FINAL DRAINAGE REPORT
FOR
STERLING RANCH EAST FILING NO. 2
&
FOURSQUARE AT STERLING RANCH EAST FILING NO. 1

October **2023**

Job no. 2183.23
PCD File # SF2236 & SF2237

INLET IN A SUMP OR SAG LOCATION

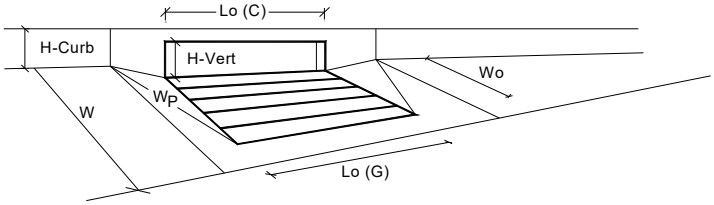
Include scenario for this inlet that includes that overtopping from DP5 to show what happens. Include small discussion within report. (Can inlet still function, how deep does flow get in roadway, etc)

DETENTION BASIN STAGE-STORAGE TABLE BUILDER

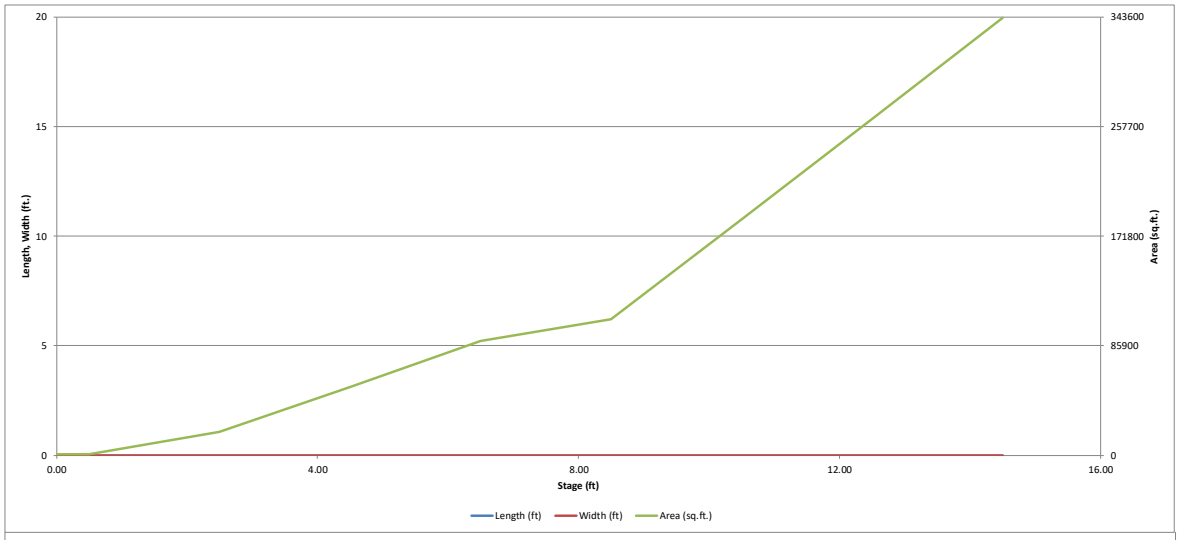
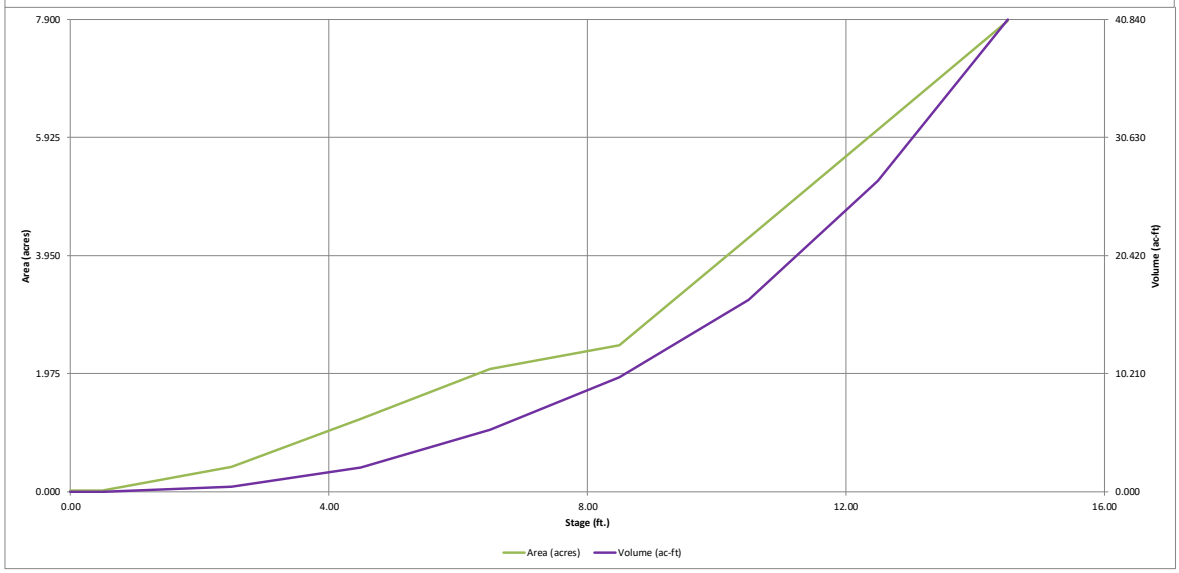
Pond detail sheet 27 in CDs shows 4:1 side slopes. Please reconcile between report and drawings to show same slope.
